Source:     RAPPORTEUR (Sakae OKUBO)  
Title:     REPORT OF THE TWENTIETH EXPERTS GROUP MEETING IN  
            YOKOSUKA (24-27 October 1995)  
Purpose:    Report  
Status:     Confirmed by the participants

Figure I. Retransmissions within H.245.

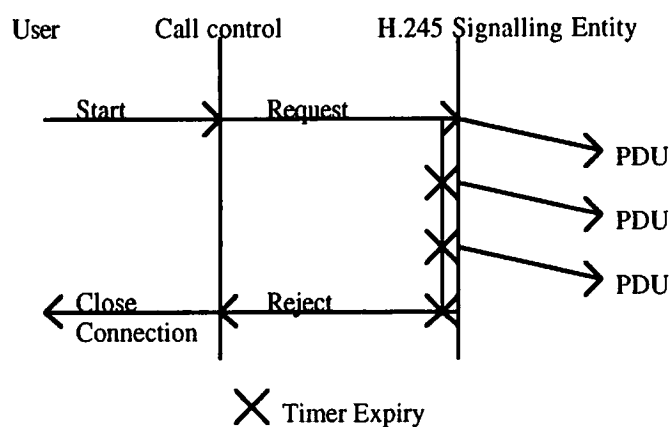
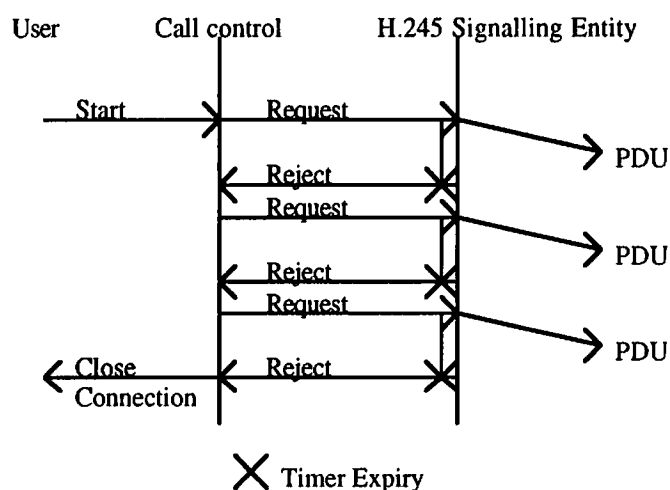
Figure I shows the behaviour when retransmissions are specified in H.245, and figure II when they are specified in the System Recommendation. It should be noted that in both cases the transmitted PDUs and the interactions with the user are the same, and occur at the same time.

It was noted that system recommendations would have to specify the behaviour in the case of protocol errors regardless of whether these occurred after one or multiple attempts.

Figure III. Bi-directional logical channel set up when reverse parameters are satisfactory to responding terminal.

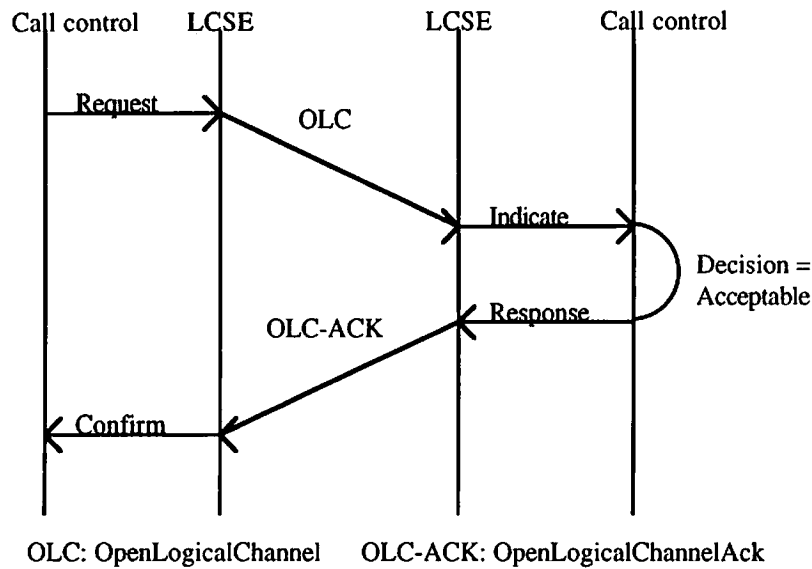
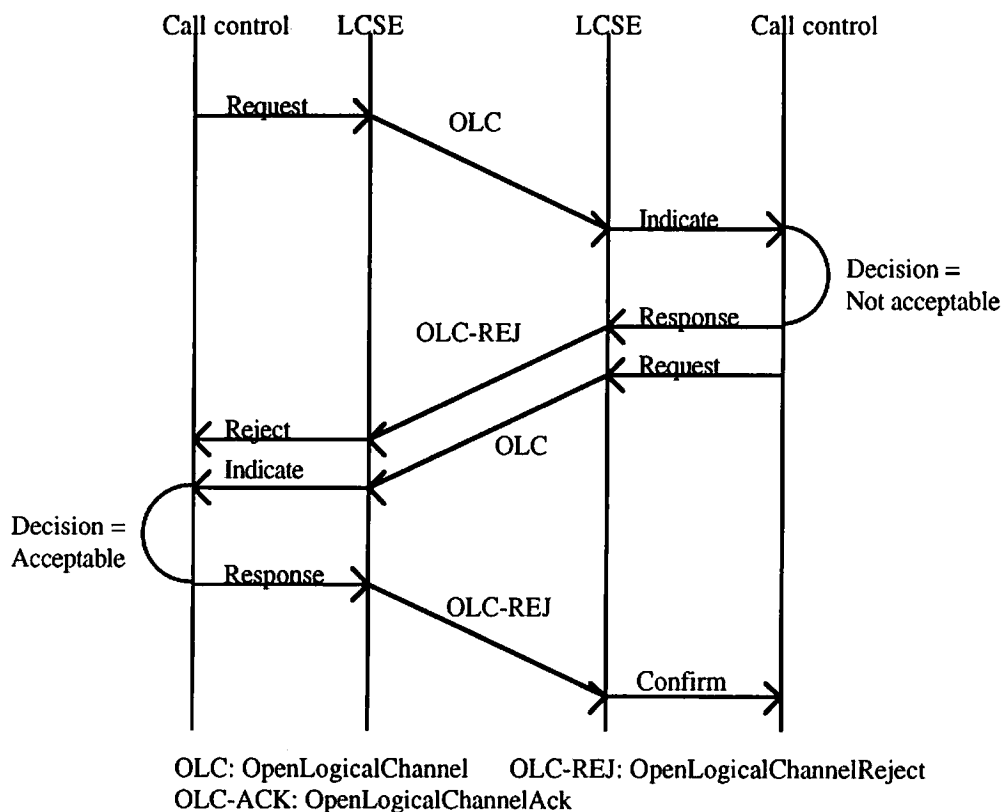
It was recognised that the initiating terminal may not know the transmission capabilities of the remote terminal and therefore might not be able to set appropriate reverse logical channel parameters, and that figure 2 of TD-19 overcame this problem. However, this solution was thought to be undesirable as it had the potential to set up half a bi-directional logical channel in the case that the responding terminal's request fails.

To overcome this, the following was agreed. The responding terminal may accept the bi-directional request if it finds it satisfactory, and the protocol is as in figure 3 of TD-19, and is identical to the uni-directional logical channel protocol. If it finds the request unsatisfactory on the grounds of the reverse channel parameters, it shall reject the request with an appropriate (new) cause, and shall immediately initiate its own bi-directional request in which the reverse parameters are equal to the forward parameters of the original request, and in which the forward parameters indicate a mode that it can transmit and which the remote terminal is known to be able to receive. These two cases of the agreed solution are shown in figures III and IV respectively.

This second case is very similar to that in figure 2 of TD-19, but has the benefit of avoiding setting up half channels and allows the uni-directional logical channel protocol to be used unchanged for bi-directional logical channel signalling.

Fig.1 Protocol stack in case of a single VC with AAL1 and AAL5.

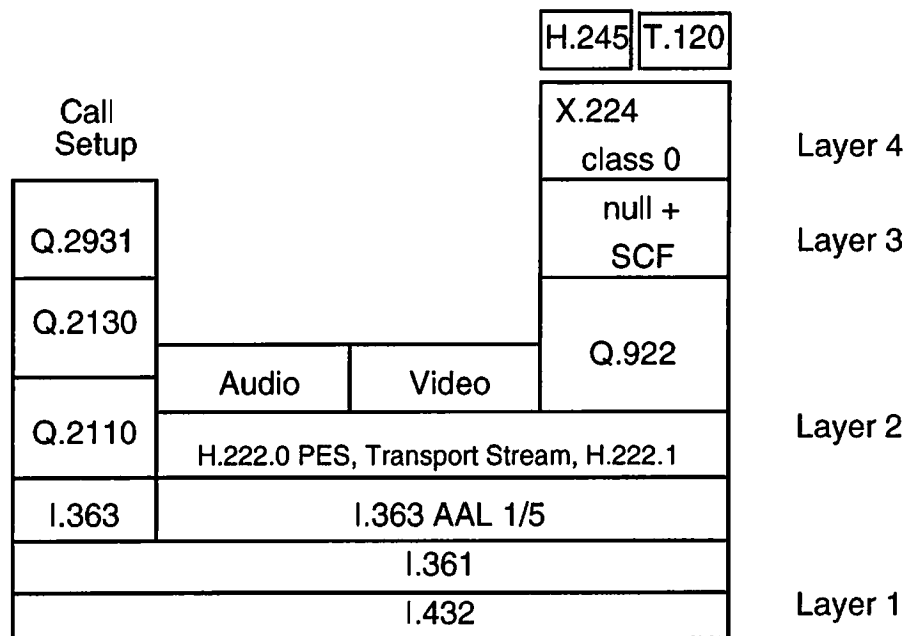
We also made a comment on your Layer 2 description in section 13.5/T.123. It is described that both stuffing bytes and Transport Stream adaptation field are not used. We think that stuffing is essential to adapt a PES packet, which conveys Q.922 PDU, to a TS packet. This mechanism can be provided by stuffing byte of TS adaptation field. Why do you think to prevent the stuffing in the TS packet level ? How do you cope with the variable size Q.922 PDU?

We would appreciate your review and comments before the determination of the revision of T.123 in your February 1996 meeting, toward our harmonized solution on the protocol stack not only in case of a separate VC but also in case of a single VC.
